U.S. Department  
of Transportation  
**Federal Highway  
Administration**

In Reply Refer To: HSA-10/B-132

In May of this year, you requested the Federal Highway Administration's (FHWA) acceptance of a truss-core aluminum F-shape bridge rail and of a symmetrical aluminum F-shape median barrier. These barriers are 34-inch tall F-shape designs consisting of base plates and posts made from 6061-T6 aluminum alloy, and upper and lower interlocking truss-core panels and top cap made from 6063-T6 aluminum alloy. Drawings of the two designs are enclosed. To support your request, you also submitted a report entitled "Design Analysis of an Aluminum F-shape Bridge Railing and Median Barrier" by Ray and Oldani at Worcester Polytechnic Institute dated May 10 that concluded, through finite element analysis, that the barrier would perform acceptably at the National Cooperative Highway Research Program (NCHRP) Report 350 test levels 3 and 4 (TL-3 and TL-4).

F-SHAPED ALUMINUM  
TRUSS CORE PARAPET  
BARRIER, NCHRP 350  
COMPLIANT AT TL-4.

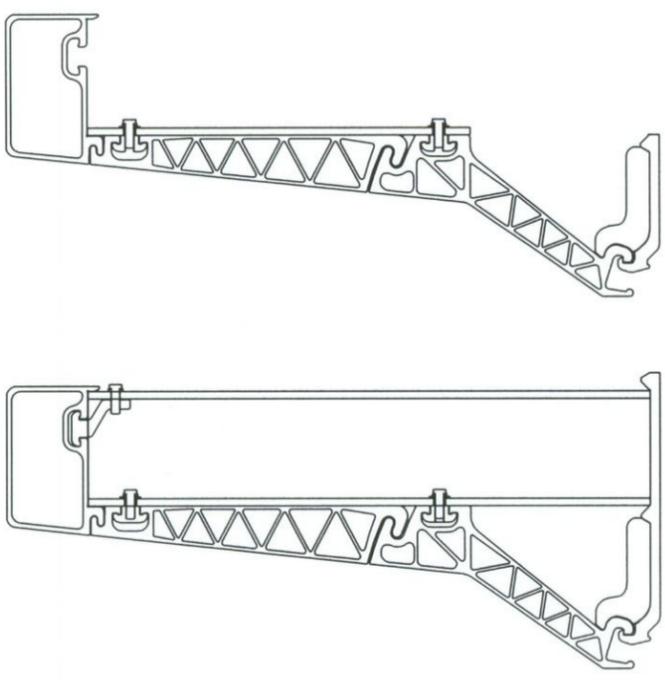
- These barriers will be fabricated with the same materials and to the same dimensions used in the finite element analysis, except that the traffic-side base plate bolts for the bridge rail will be increased from 1-inch diameter A325 galvanized steel to 1.125-inch diameter A325 galvanized steel and the field side bolts will be increased from 5/8-inch diameter A307 bolts to 3/4-inch diameter bolts. These modifications are shown on the enclosed drawings.

TRAFFIC SIDE  
ANCHORS ARE  
1 1/8" A325 EQUIVALENT  
ⓐ WAS 1"Ø

REAR ANCHORS  
ARE 3/4"Ø AND  
A307 EQUIVALENT  
ⓐ WAS 5/8"Ø
